**THE VILLAS AT CLAREMONT RANCH**  
**GRADING & EROSION CONTROL PLAN**

SF-22-028

**THE VILLAS AT CLAREMONT RANCH**  
GRADING & EROSION CONTROL PLAN

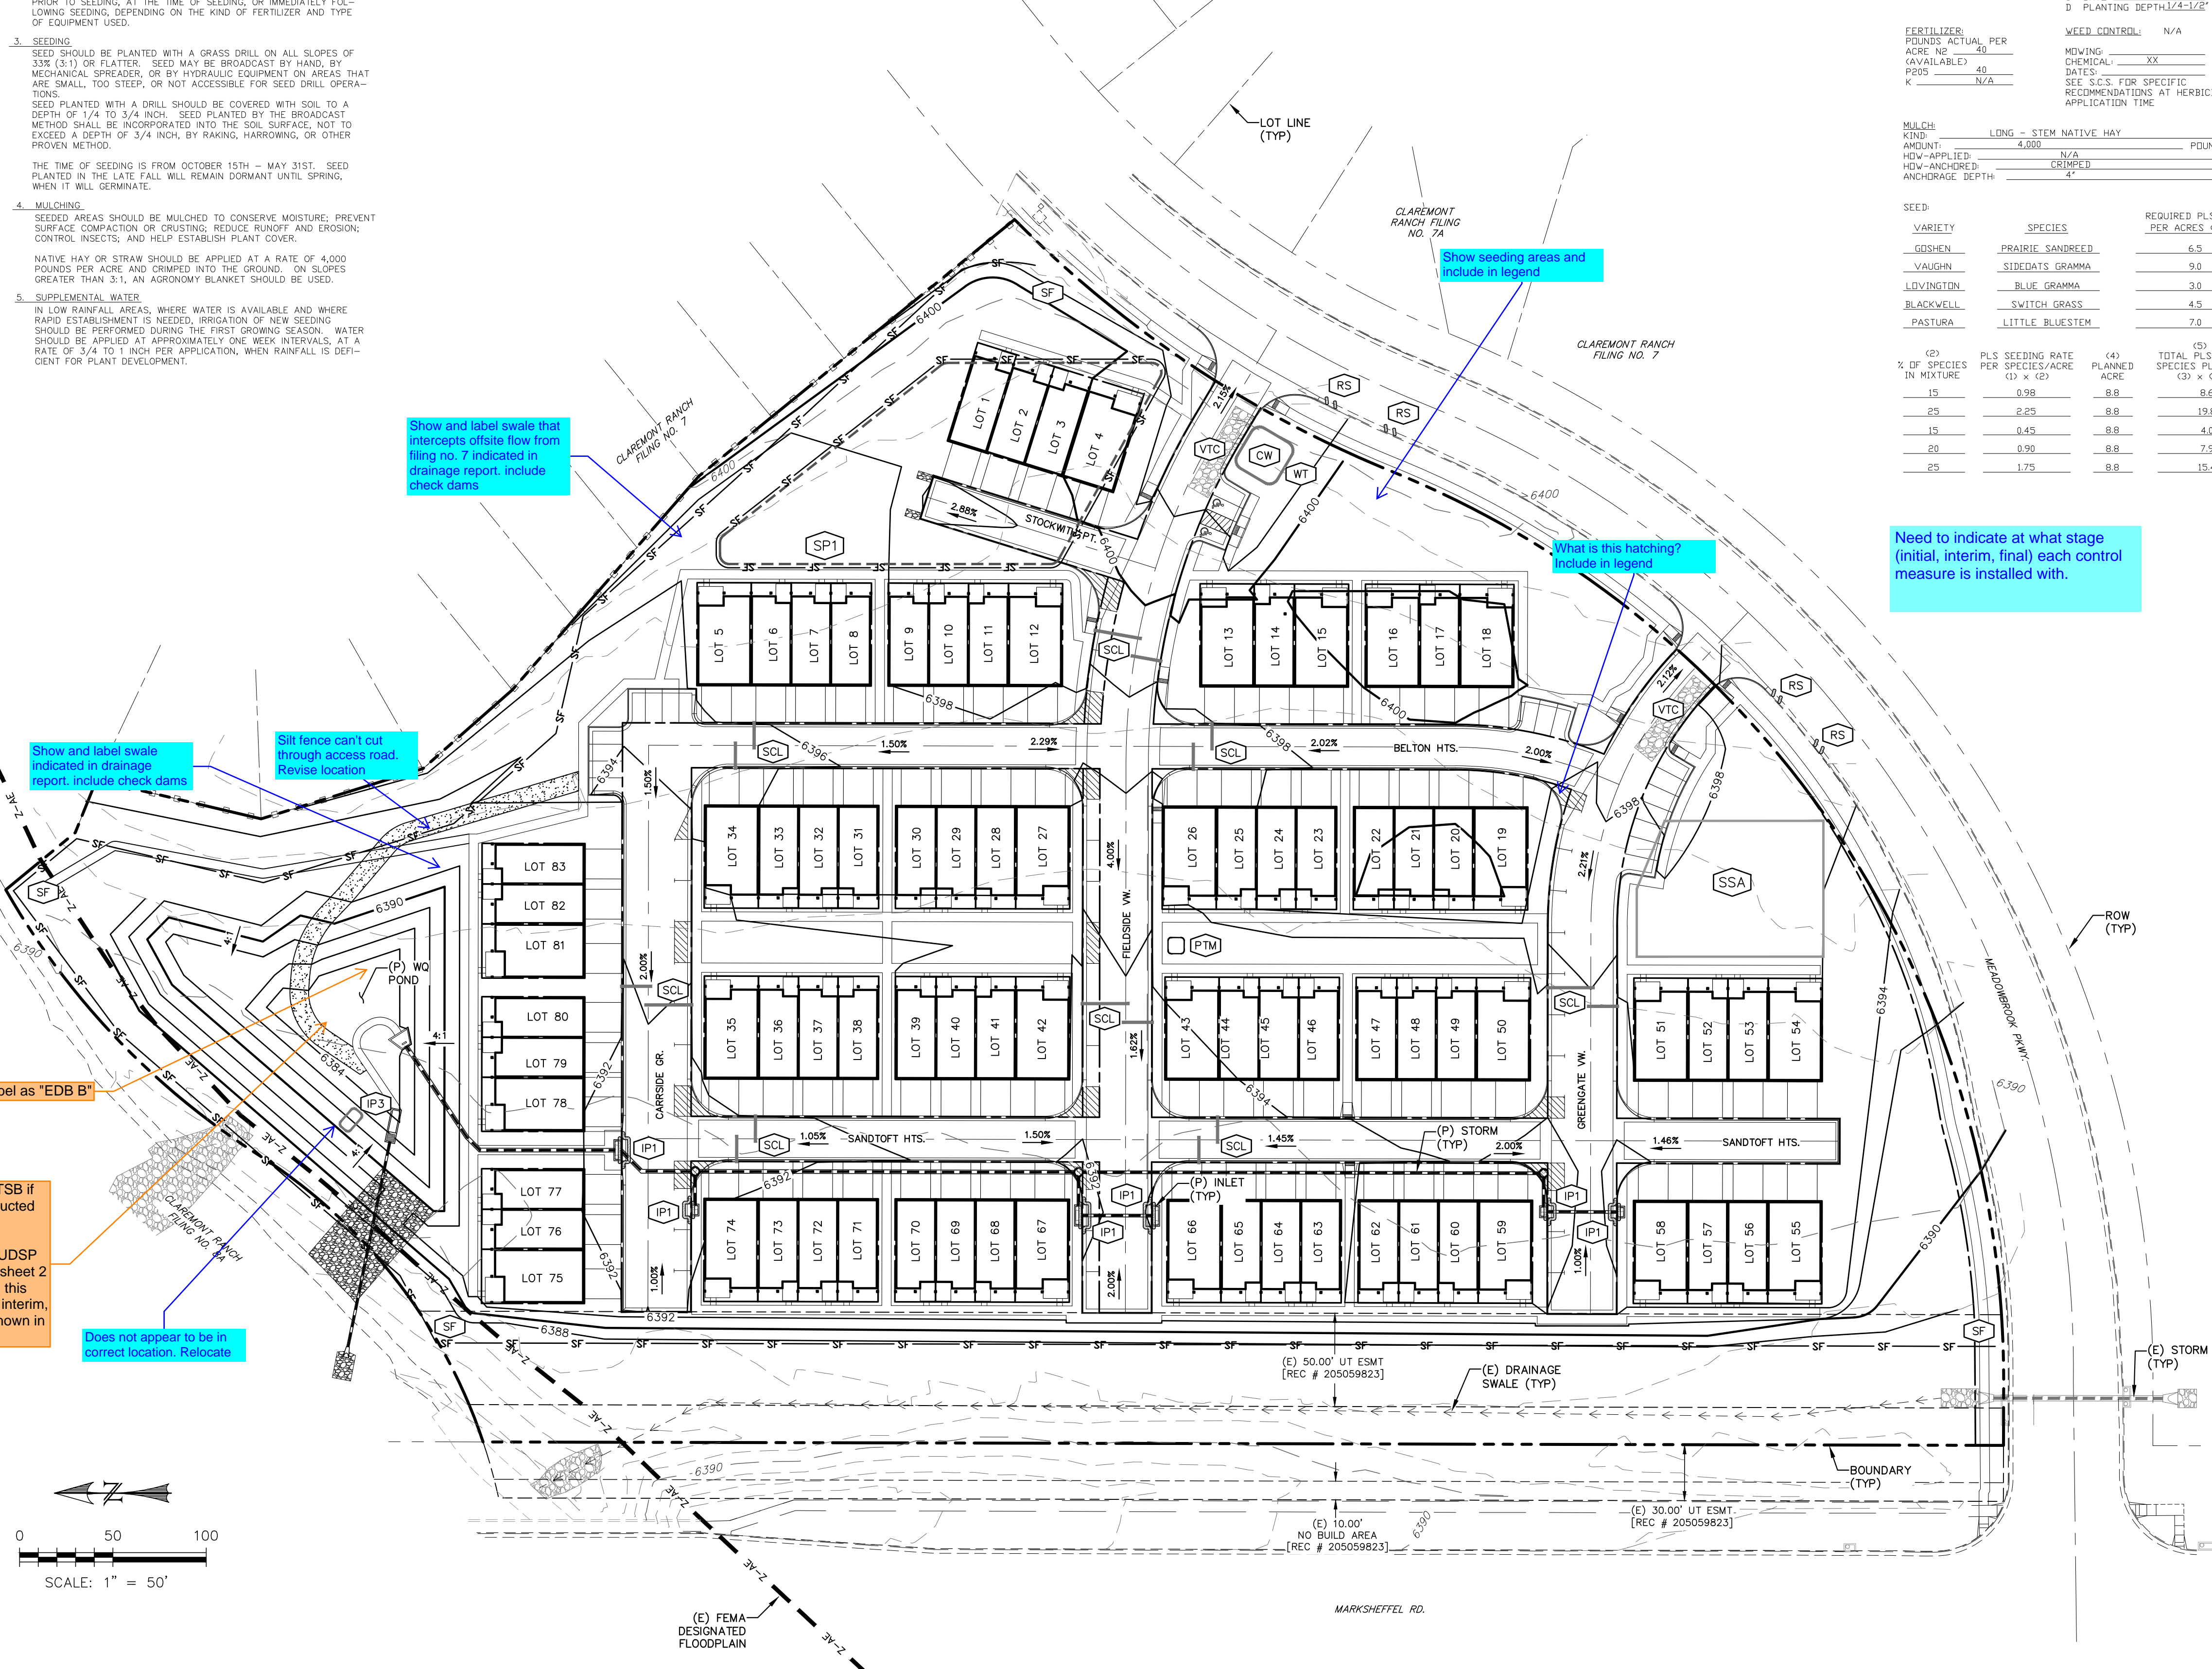
Items H and M. If "limits of disturbance" and "construction boundary" are the same, change to "limits of construction/disturbance" or otherwise show as separate line types for each on the legend and figure.

label all items as interim or final.

Show a bubble for a TSB if one was never constructed with the PUDSP.

If grading shown in PUDSP never occurred, show sheet 2 of that GEC Plan with this SF, so that the initial, interim, and final BMP's are shown in one planset.

Does not appear to be in correct location. Relocate

Include WT in legend

THE VILLAS  
AT CLAREMONT RANCH  
GRADING & EROSION CONTROL  
DETAIL SHEET

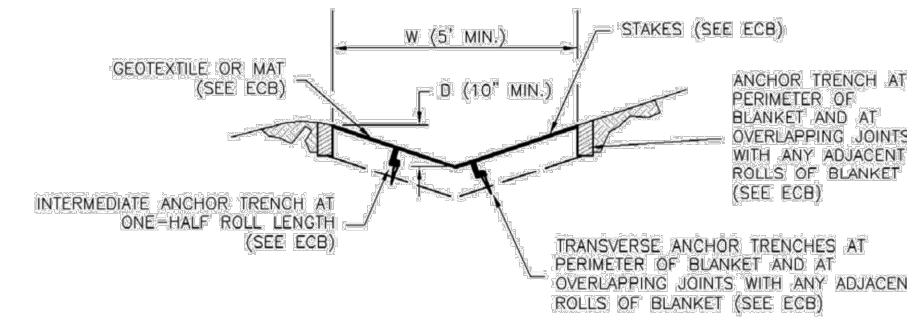
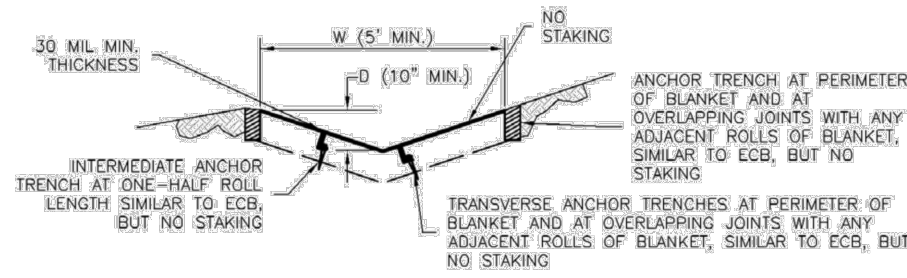
Include seeding and mulching detail

Item Z. Include details for the following BMP's. Examples of acceptable details for each are provided:

BMP	Detail # and Source		
	DCM (Vol 2: Chap 3.3)	MHFD (USDCM Vol 3: Chap 7)	COS - Stormwater Construction Manual (App E)
Mulching	MU-1	EC-4	X
Seeding	TS-1	EC-2	X
